client
 Dr I Gilkar
 project
 Corby, Birkby Road, Huddersfield,
 HD2 2DR
 drawing
 Proposed Elevations 2 of 2

scale	date	drawn	revision
SHOWN@A3	30.06.22	RL	
drawing no.	RG324 / PL06		D

Proposed South Elevation - 1:100

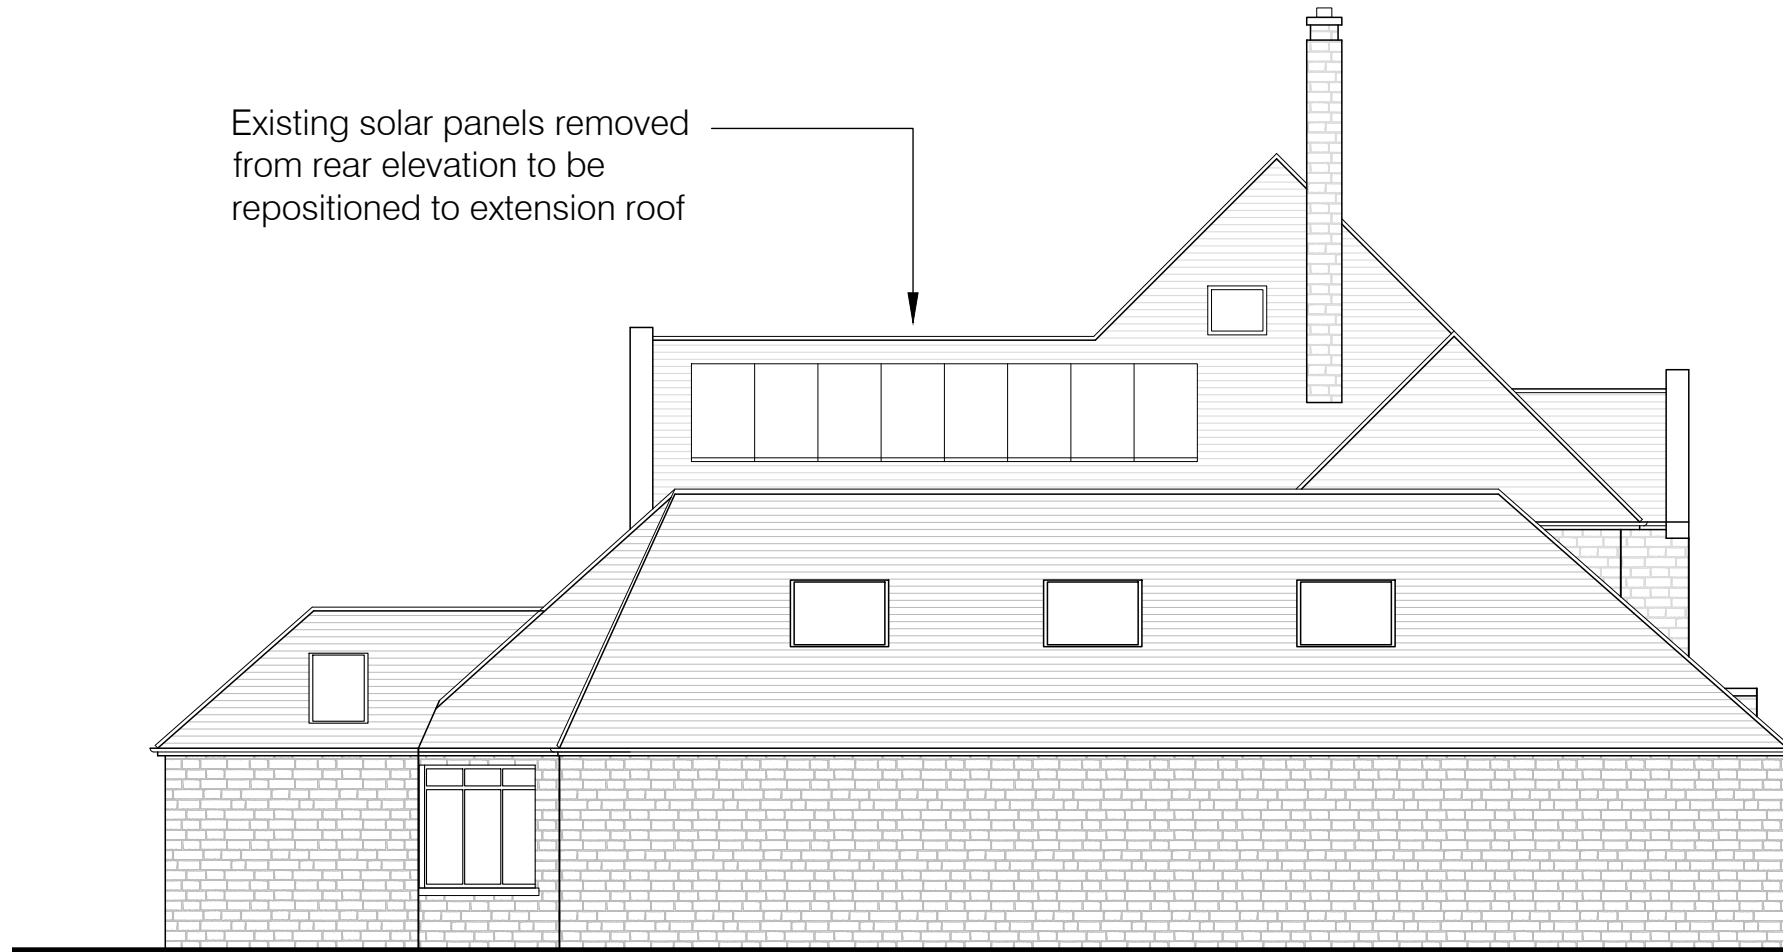
Existing solar panels removed
from rear elevation to be
repositioned to extension roof

Rev D - South elevation altered in accordance with planner comments and solar panels repositioned - 13.09.23
 Rev C - Planning Submission - 30.03.23
 Rev B - Extensions added and drawing reference revised - 11.03.23
 Rev A - Balconies added - 23.02.23
